CONTROL DISCREPANCY

AMENDMENT TO HUMAN ENGINEERING REQUIREMENTS SPECIFICATION

PLANT: V. C. Summer Nuclear Station

VERTICAL INDICATOR SPECIFICATION

CMC SWITCH INSERT

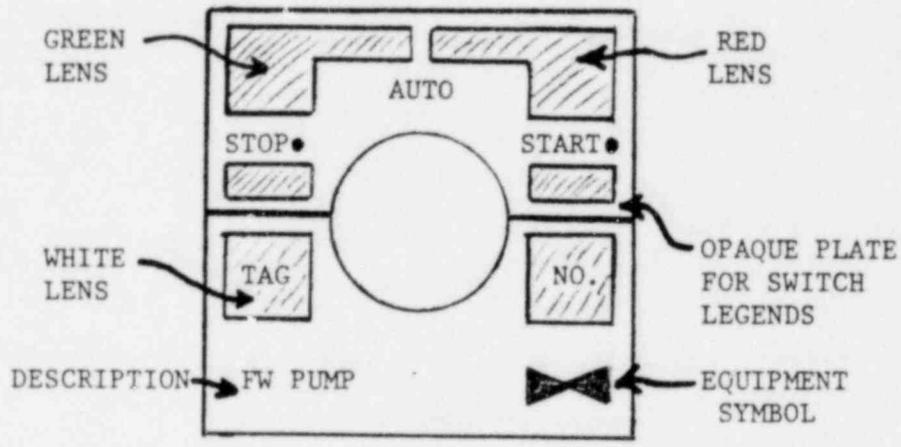
- 2.1i. Legend labels on the controls are inconsistent (automatic sometimes means closed). (Category 1)
- 2.1j. Component number (or other information) that is engraved on the red and green lenses are difficult to read, particularly when the green lenses are not illuminated. (Category 2)

Switch select position legends will be effectively disassociated from the indicator lights that display equipment status information. In addition, low contrast information remaining on colored lenses will be top engraved with white lacquer filled to attain the legibility required. The specification for implementing this backfit will be developed. See page 12A for typical example.

ATTACHMENT B

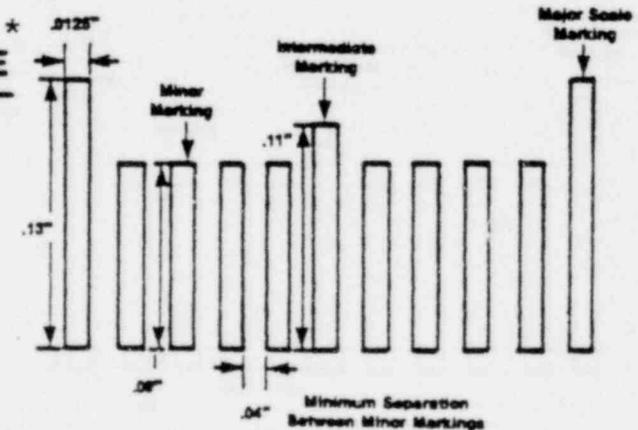
* See Page 10 for (1) press to apply lettering sizes used to approximate recommendations and (2) modifications to recommended scale marking size.

- B. Recommended scale marking sizes for dual scale meters were modified to increase discriminability. Revised scale markings are as follows:

<u>LENGTH</u>	<u>STROKE WIDTH</u>
MAJOR	.13"	.03"
INTERMEDIATE	.10"	.02"
MINOR	.07"	.0125"

FIGURE 1
ANNUNCIATOR CHARACTER SIZE SPECIFICATIONS

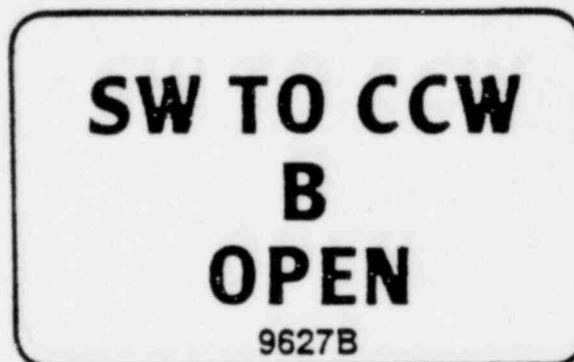
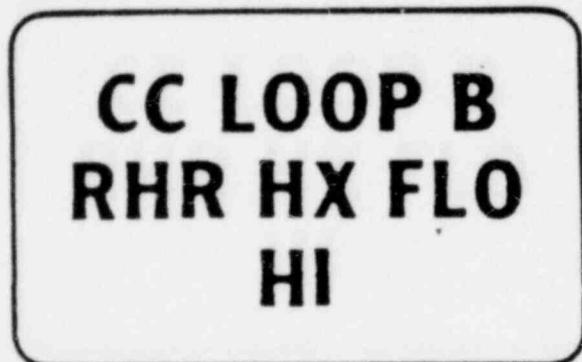
* Figures represent as built modifications to the character size stipulated in the specification as originally issued in January, 1981. The modified size, although somewhat smaller than originally specified, does meet human factors criteria for readability (1/82).

- a. Total annunciator tile width is 2.75".
- b. Total annunciator tile height is 1.75".
- c. Visible ** annunciator tile width is 2.318"
- d. Visible annunciator tile height is 1.12".
- e. Viewing angle from normal operator position and annunciator panels 601 and 638 is 35° and 45°, respectively (see Figure 2).
- f. Left and right margins are .216".
- g. Top and bottom margins are .315".
- * h. Height of character is .22".
- * i. Width of character is .13".
- * j. Strokewidth is .03".
- * k. Character separation is .03".
- * l. Word separation is .13".
- * m. Line separation is .11".
